REMARKS

This is in response to the Office Action dated March 21, 2005, in which Claims 19-22 were withdrawn from consideration by the Examiner, Claims 1-14 and 23-24 were rejected, and Claims 15-18 were allowed. Claims 1, 9-10, 12-14 and 23 have been amended as above, and Claim 11 has been canceled without disclaimer or prejudice. It is respectfully submitted that, as amended, all the pending claims are allowable.

Application No.: 10/756,858
Response to Office Action of 03/21/2005
Attorney Docket: Norte-523A

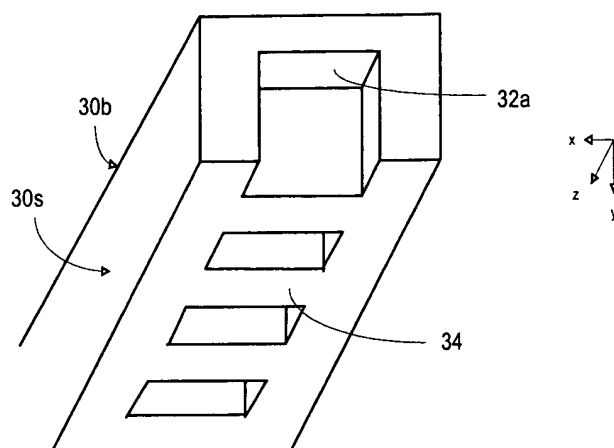
The Examiner objected specification and indicated that in paragraph [0022], it is unclear as to how the applicant is defining "ridge" and "trench". The Examiner suggested that ridge "32" should be changed to --34-- and trenches (i.e. hollow portion) "34" should be changed to --32-- (see fig. 4).

The Applicant respectfully traverses the objection because definitions of the ridge 32 and the trench 34 are relative terms depending on the viewing direction and the reference point/object. For example, when one observes the slow-wave structure 10 in a reversed direction as shown in the following drawing, the ridge and trench behaviors of 32 and 34 can be easily seen.

Alternatively, although the structure 32 is recessed from the top wall 30t as described in paragraph [0022] of page 5, while observing the waveguide 10 from the interior side thereof, the structure 32 also appears to be a ridge protruding into the rectangular profile defined by the conductive top wall 30t, sidewalls 30s, and bottom wall 30b. In other words, to a wave that propagates through the channel defined by the waveguide 10, the structures 32 appears to be a ridge which changes the rectangular propagation path as shown in Figure 6 into a path as shown in Figure 5. The structures 34 recessed from the ridgeline of the structure 32 behave like trenches relative to the ridge 32.

Fig. 3

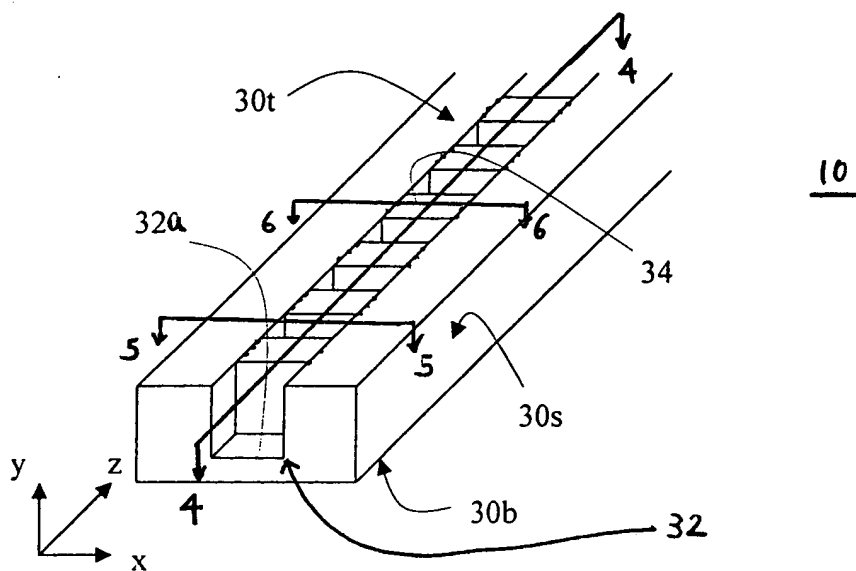
Figure 3 has been amended to overcome the objection.

In Figure 3, numeral references 10 and 32a have been added to indicate the slow-wave structure of the ridge waveguide and the ridge segments, respectively. In addition, the cutting lines 4-4, 5-5 and 6-6 along which the cross sectional views are taken as shown in Figures 4, 5 and 6 are added.

Fig. 4

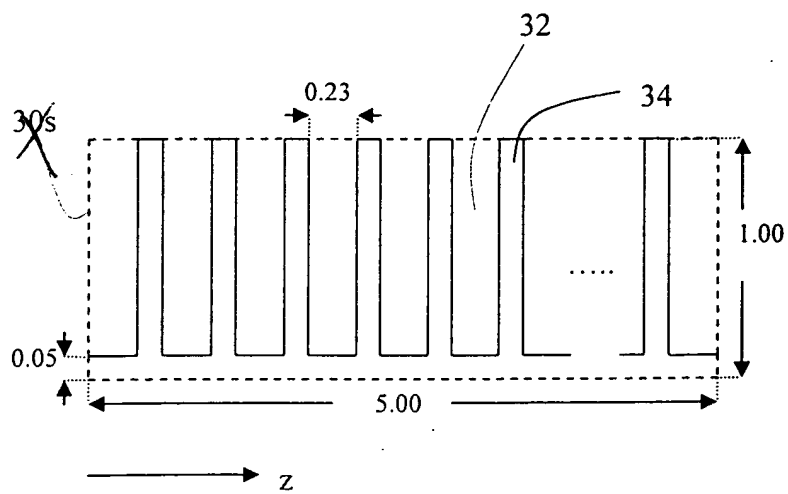
In Figure 4, the reference numeral "30s" has been deleted.
